October 12, 1985
ST-HL-AE-1418
File No.: G9.17

South Texas Project
Units 1 and 2
Docket Nos. STN 50-498, STN 50-499
Responses to DSER/FSAR Items -
FSAR Sections 2.4, 3.4 and 3.5

The attachments include mark-ups of FSAR pages which will be incorporated in a future FSAR amendment unless otherwise noted below.

Figure 3.4-1

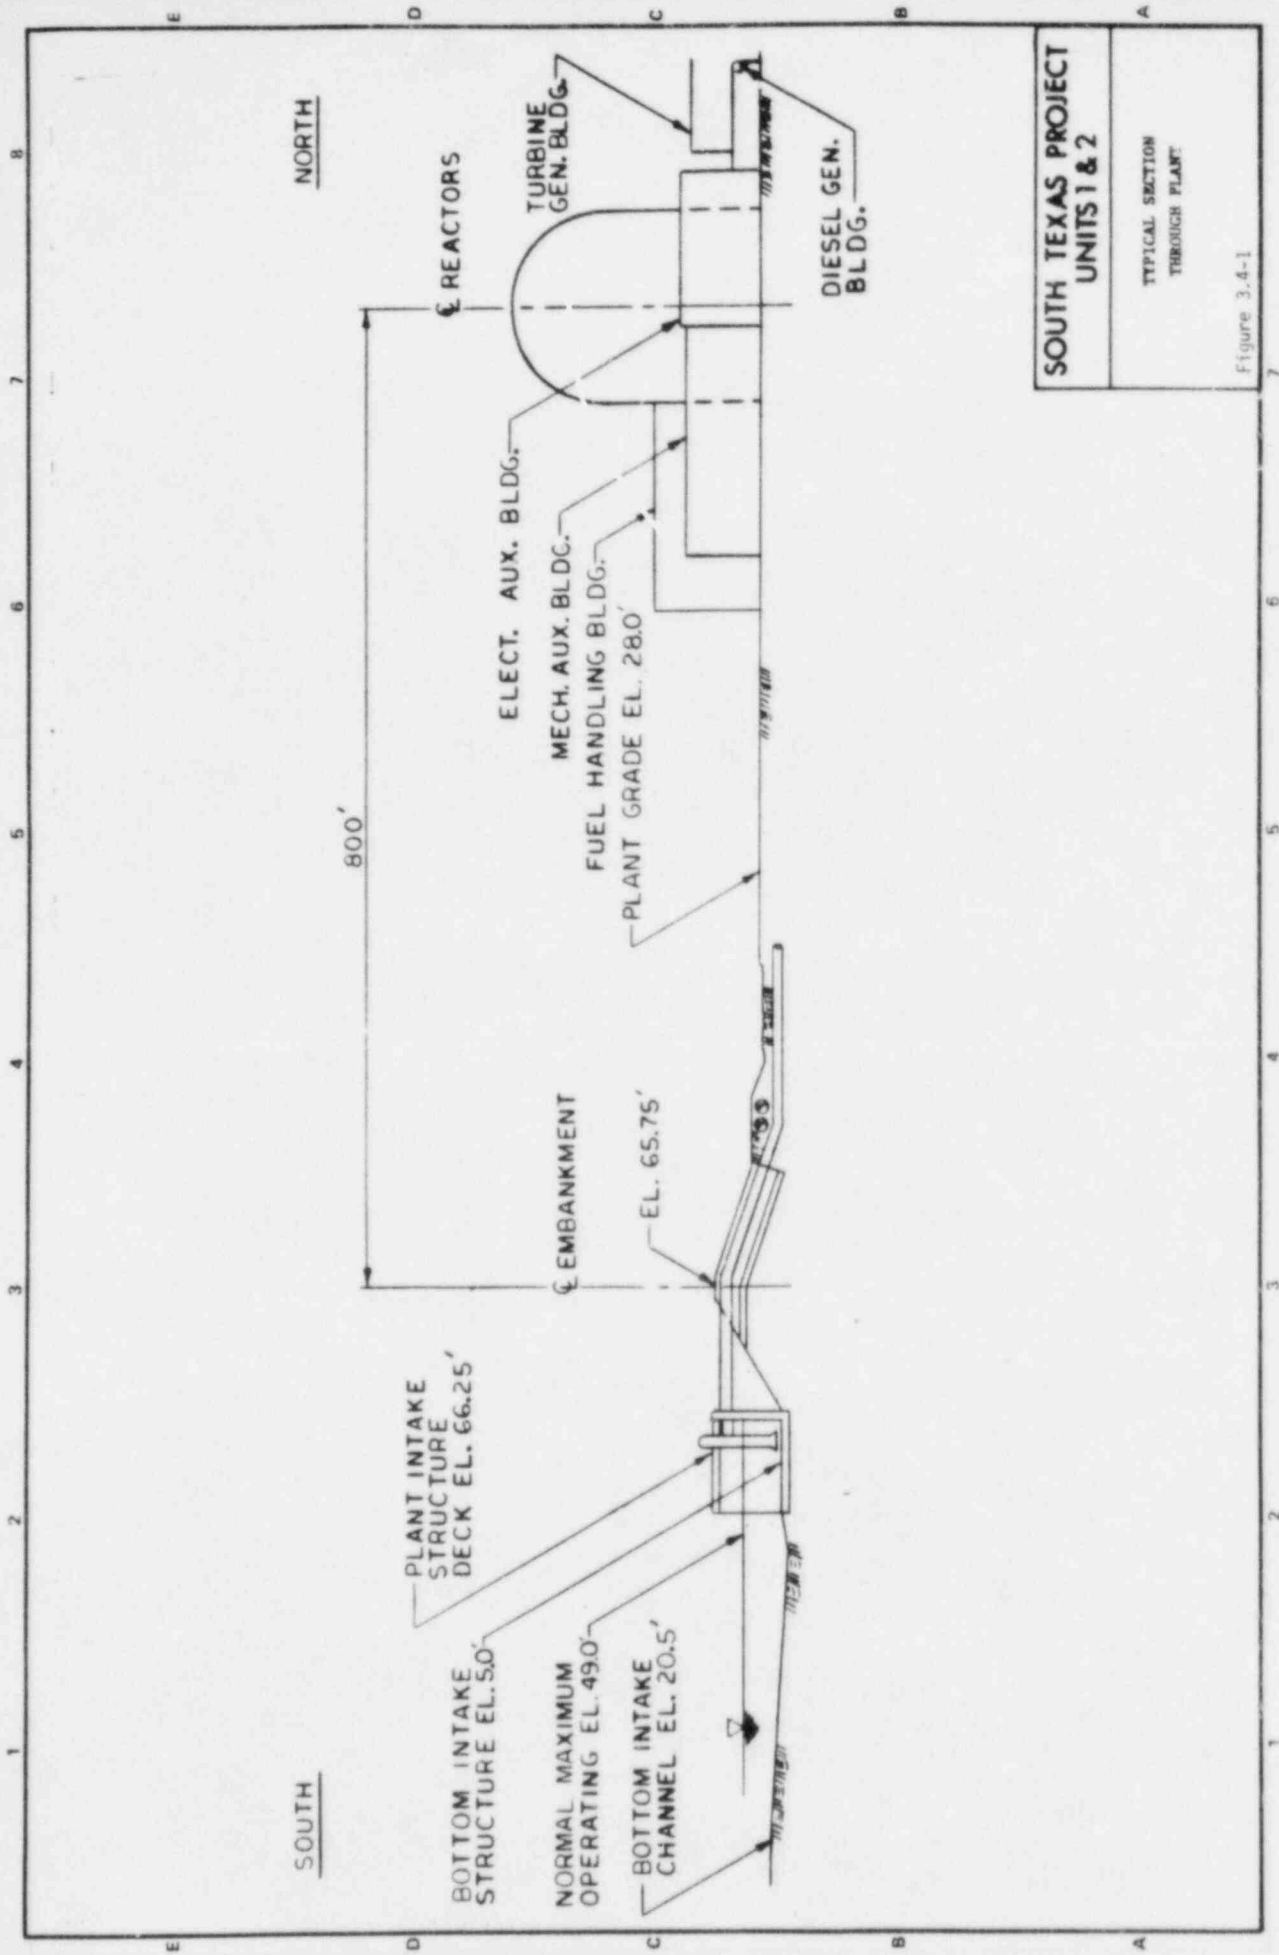
Figure 3.4-1 shows a general section through the plant. Figure 3.4-2 shows the maximum steady-state water surface profile, and the corresponding relationship of sill elevations for entrances to seismic Category I building areas.

Figure 3.4-2

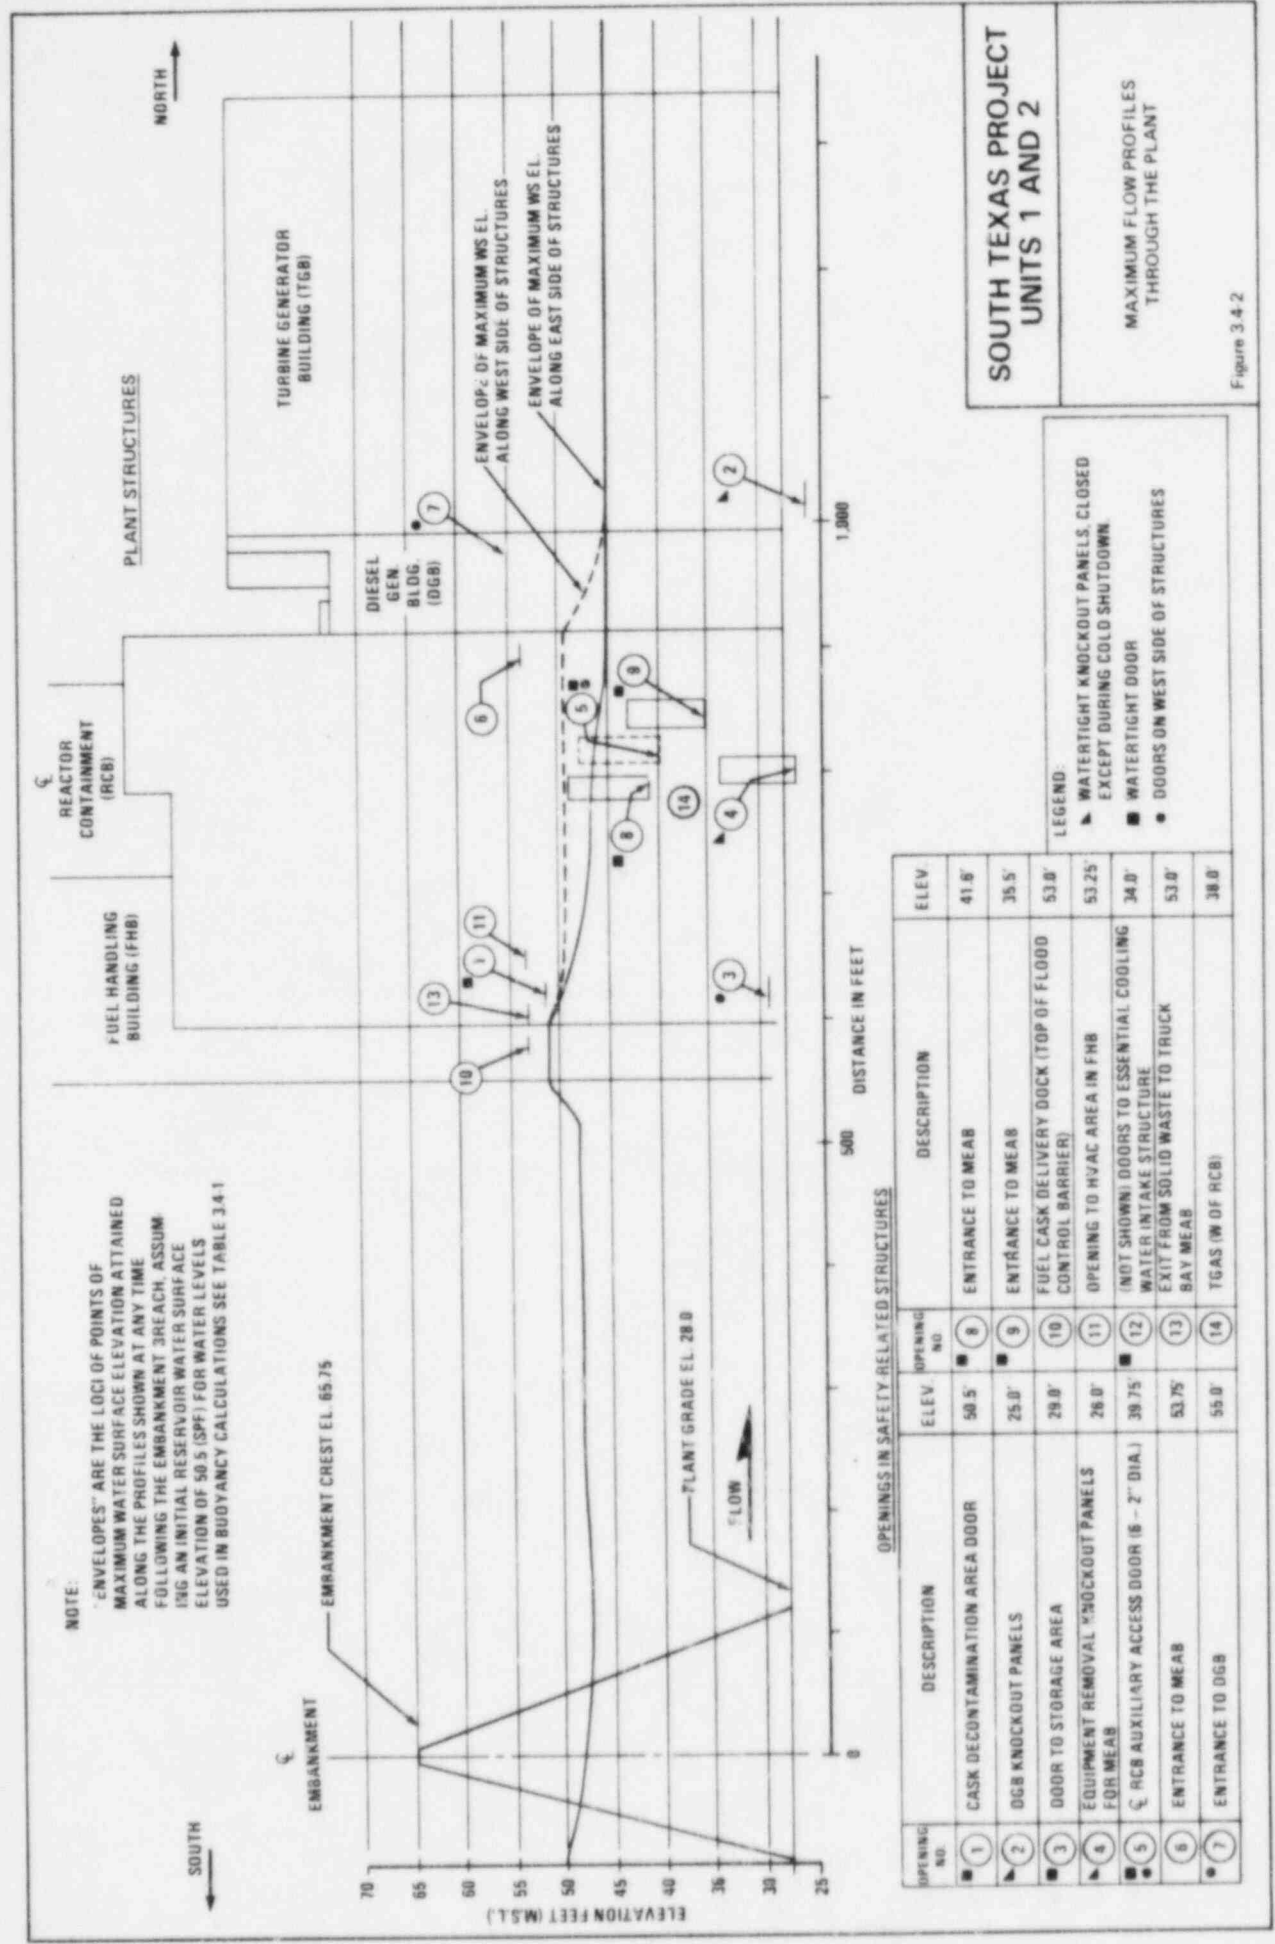
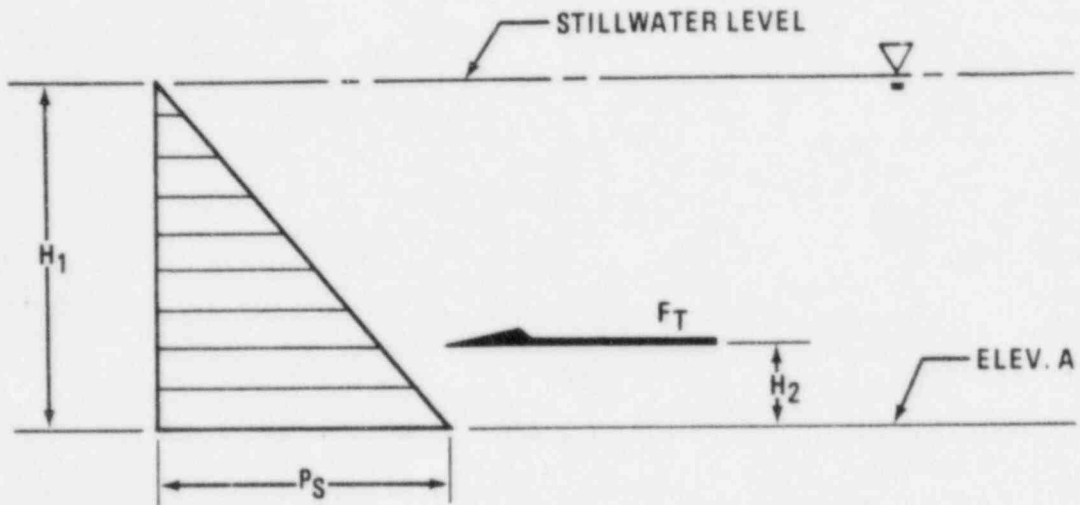
Your response to our Request 010.2 is not complete. Identify major penetrations on exterior walls of safety-related buildings that are below the design flood levels. Explain the methods of flood protection provided for these penetrations.

The design provisions for flood protection are provided in Section 3.4.2. Revised Figure 3.4-2 illustrates the locations of openings in Category 1 structures, located below El. 55.0 ft MSL. The actual design maximum flood elevations for the different buildings are defined in Table 3.4-1. The table below identifies the openings of exterior exposed walls below the actual design maximum flood elevation and the type of protection provided.

Response : See FSAR Section 3.4 and Figure 3.4-2.
